ORIGINATION FORM

Proposed Revisions to a Standard Plans Index
(Please provide all information — Incomplete forms will be returned)

Index Number: 639-002

Index Title: Electric Power Service

UNDERGROUND PEDESTAL
MOUNTED METER
FIGURE F

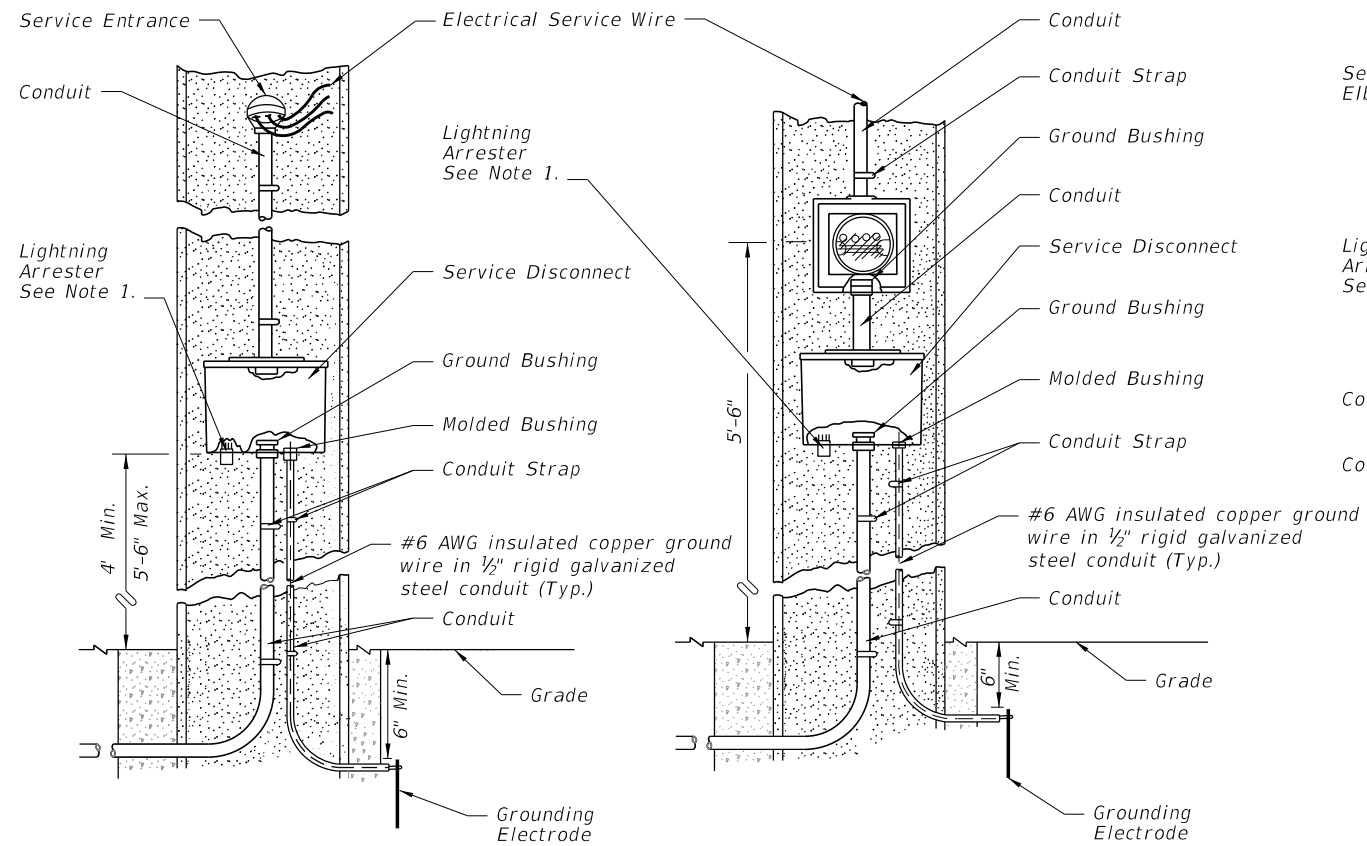
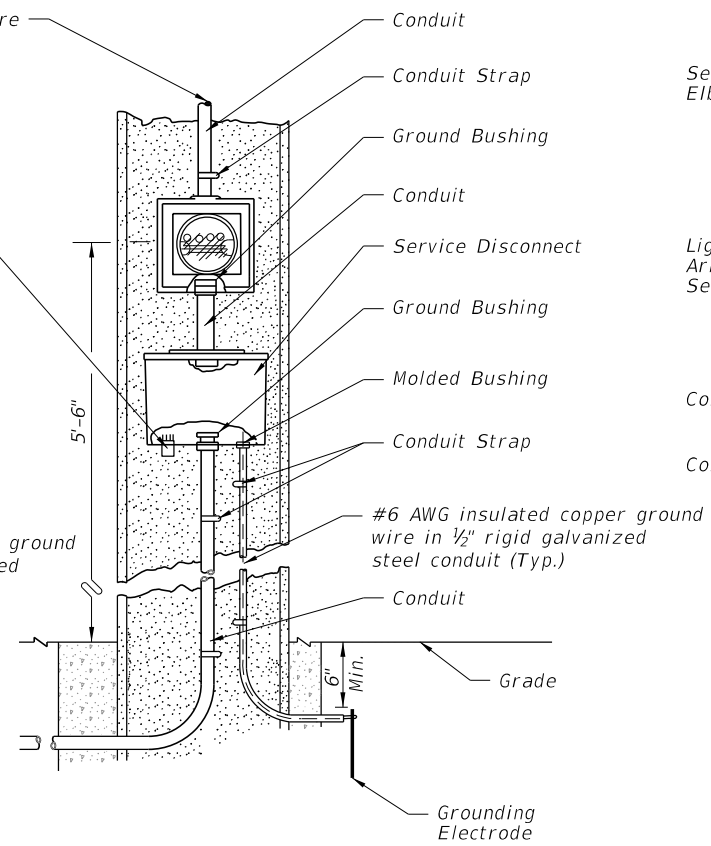
Added new figure for underground pedestal mounted meter.

Underground pedestal mounted meters have become more prevalent for new power services.

ADDED: New Detail
